## **Proposed Infill Dwelling**

**46 Limekiln Road**

**Response to Request for Further Information**

**Ref. SD22A/0386**

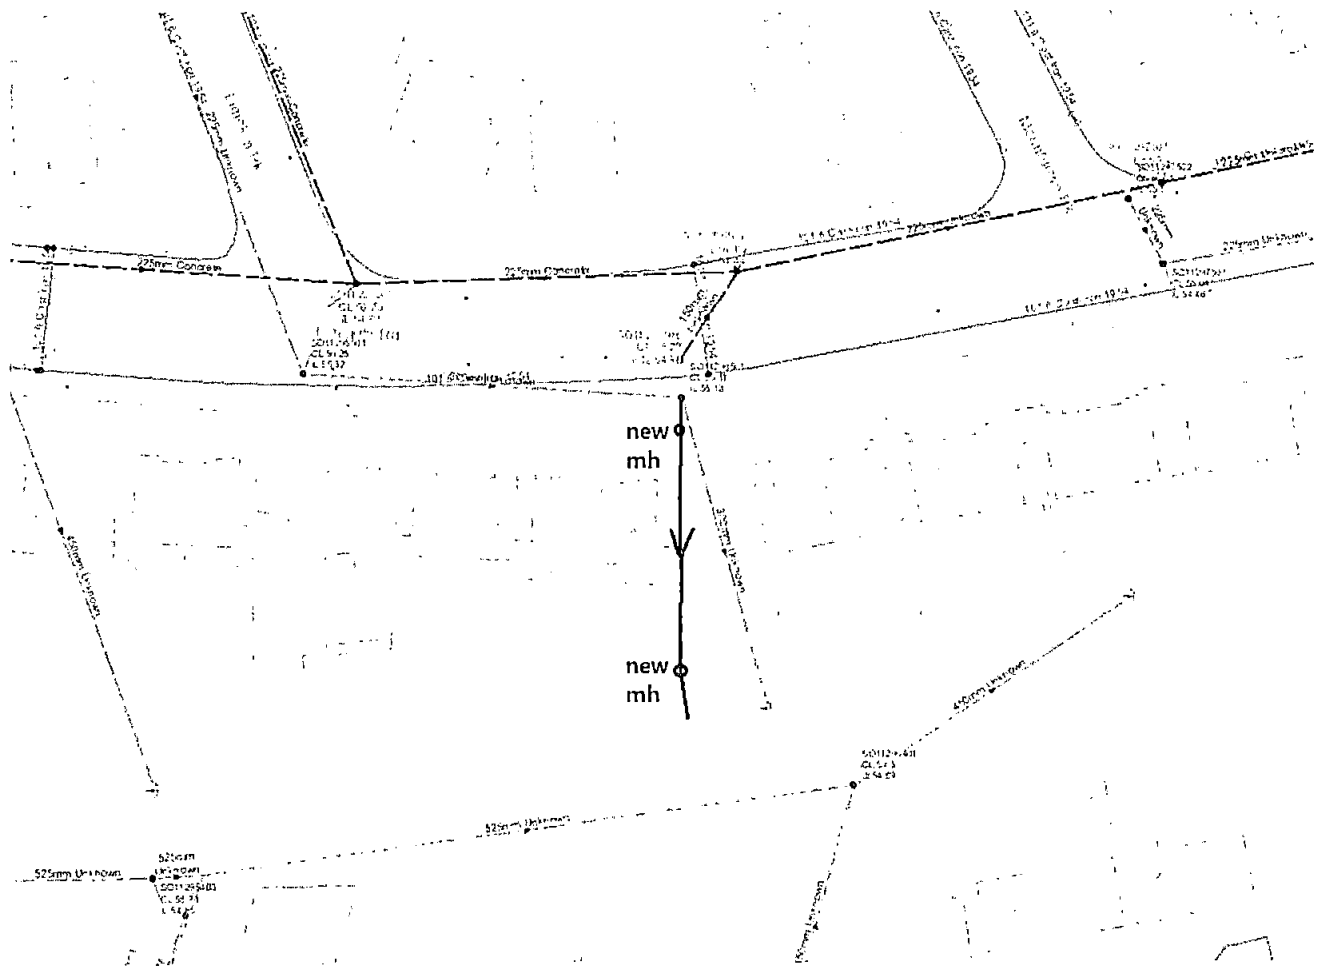
We are currently at pre-planning stage on a single dwelling at No. 46A Limekiln Road, Terenure, Dublin. There is an existing 300mm diameter stormwater sewer which traverses the site as shown below. As part of the works, we propose to divert this as shown below. The new pipe will match the diameter and gradient of the existing and we propose to greatly improve the situation by introducing a new one way valve (tideflex or similar) to prevent surging from the Poddle River South of the site. We will also be commissioning an independent site specific flood risk assessment who will be in touch separately.

Planning permission was previously approved for the proposed development ref. SD07/0710. This has since lapsed and the client wishes to effectively re-apply for this planning.

We will incorporate soft SuDS into the proposed development also and will submit full site specific drainage layouts as part of the application once complete. At this stage however can SDCC please confirm that the proposed diversion is acceptable in principle as this is no different than the proposal previously approved under SD07/0710. From the previously granted permission we note also that a 6m wide wayleave was proposed along the length of the diverted sewer which we assume is still sufficient. You might please confirm if acceptable to SDCC.

In principal regarding proposed development, an application can be considered. There would need to be a minimum 3m setback distance to outside diameter of surface water sewer from existing and proposed development.

There should be an avoidance of right angle bends in changes of direction of surface water sewer and change in direction should be more gradual to allow for an easier flow of water and reduce risk of blockages in pipeline.

There should be no load transfer to surface water sewer and development loading needs to be outside the 45 degree zone of influence to surface water sewer.
